DAGBASI HYDROELECTRIC POWER PLANT VALIDATION REPORT

Project Title	Dagbasi Hydroelectric Power Plant
Version	02
Report ID	CER.TR1272528.12.C45

Report Title	Dagbasi Hydroelectric Power Plant Validation Report		
Client	Alperen Elektrik Uretim A.S		
Pages	138		
Date of Issue	02/07/2014		
Prepared By	Bureau Veritas Certification		
Contact	Centrum Is Merkezi Aydınevler Sanayi Cad. No:3 34854 Kucukyali Maltepe Istanbul/TURKEY Tel: +90 216 518 40 50 www.bureauveritas.com		
Approved By	Anna Kalecheva		
Work Carried Out By	Furkan Sadıkoğlu – Team Leader Murat Gencer – Financial Specialist Yildiz Arikan – Baseline Specialist Burcu Mutman – Internal Technical Reviewer

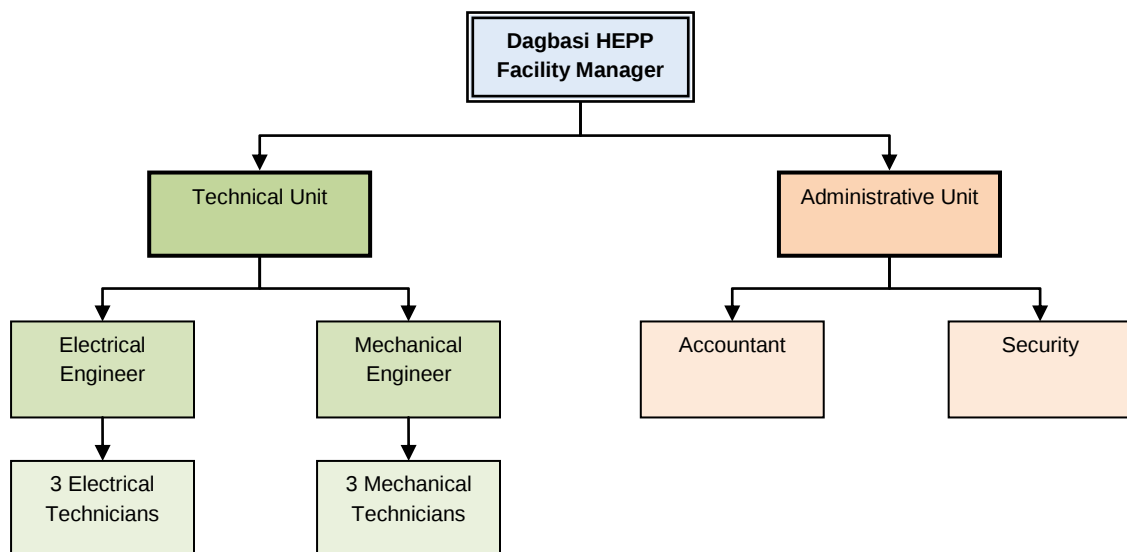
CAR04 has been raised by the validation team for the role diagram. Role diagram is added under section 4.3 of the VCS PD and the corrective action request is closed.
